TENNESSEE VALLEY AUTHORITY

Enclosed is TVA's evaluation of the draft of an NRC staff interim position on masonry walls which was provided informally to TVA on July 8, 1981. This evaluation, which includes TVA's interpretation of applicability to Watts Bar Nuclear Plant, is being provided as specified in the TVA/NRC telephone conference call on August 13, 1981.

ENCLOSURE
WATTS BAR NUCLEAR PLANT UNITS 1 AND 2
RESPONSE TO INTERIM NRC POSITION ON MASONRY WALLS

TENSILE BOND STRENGTH VS. MORTAR CUBE STRENGTH

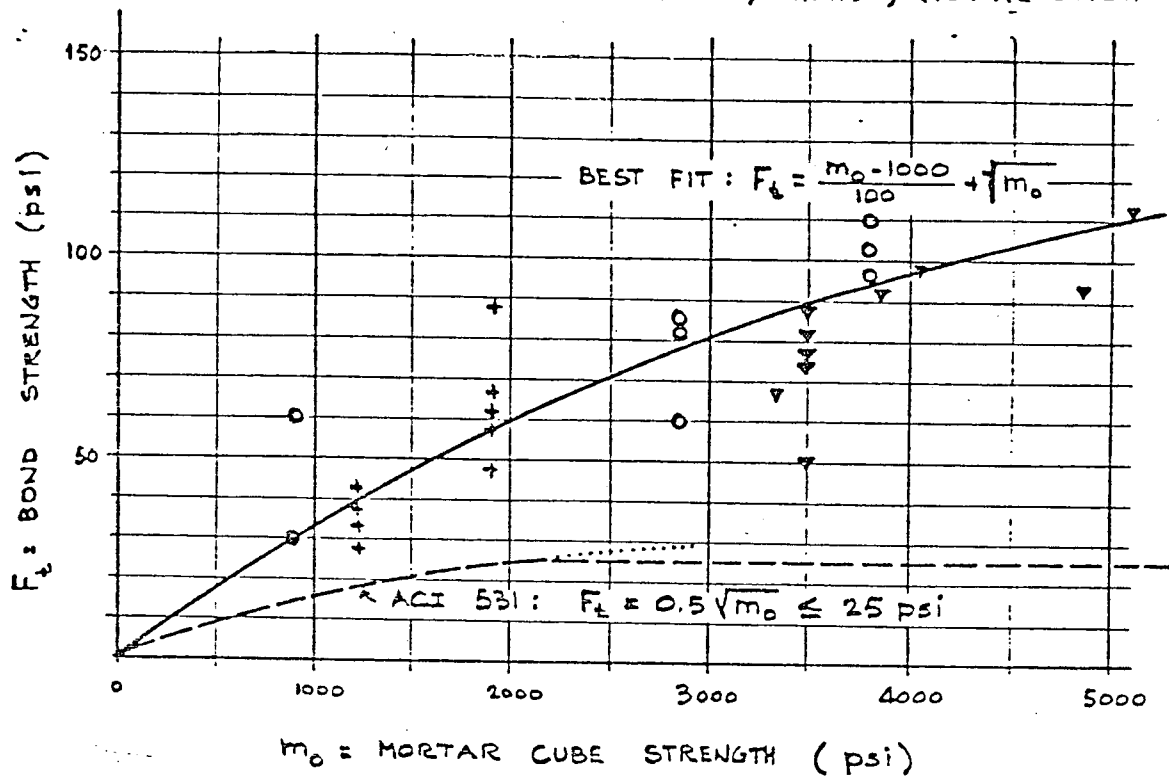
Paragraph (c) states, "When tension perpendicular to bed joints is used in qualifying the unreinforced masonry walls, the allowable value will be justified by test program or other means pertinent to the plant and loading conditions. For reinforced masonry walls, all the tensile stresses will be resisted by reinforcement."

As demonstrated by TVA's criteria in Reference 2 for the reinforced masonry walls, the tensile stresses in the walls are resisted only by the reinforcement. For the unreinforced walls, TVA's criteria as presented in Reference 3 allows tensile stress in the mortar perpendicular to the bed joint equal to the allowable stresses as given in ACI 531-79. The criteria further requires, in accordance with ACI 531-79, that where construction records conforming in general to the requirements outlined in section 4.5.2 of ACI 531-79 are not available, the allowable tensile stress will be reduced by one-half.

TVA believes the allowable tensile stress perpendicular to the bed joint as specified by ACI 531-79 is adequate and acceptable for design purposes. The attached graph represents the testing program data from which the ACI 531 committee based its code. In these tests unreinforced masonry walls (usually 4 feet wide by 8 feet high) were constructed in the laboratory and restrained at the top and base. A vertical strip of uniform load (an inflatable air bag) was applied to these walls. The walls were loaded to tensile failure and plot of the tensile bond strength of the mortar versus mortar cube strengths has been recorded by the National Concrete Masonry Associates and others (see attached). As the graph shows, the ACI 531-79 allowables for tensile stress are very conservative and therefore justifiable for usage. TVA, therefore, does not presently propose any additional testing to justify this allowable tensile stress.
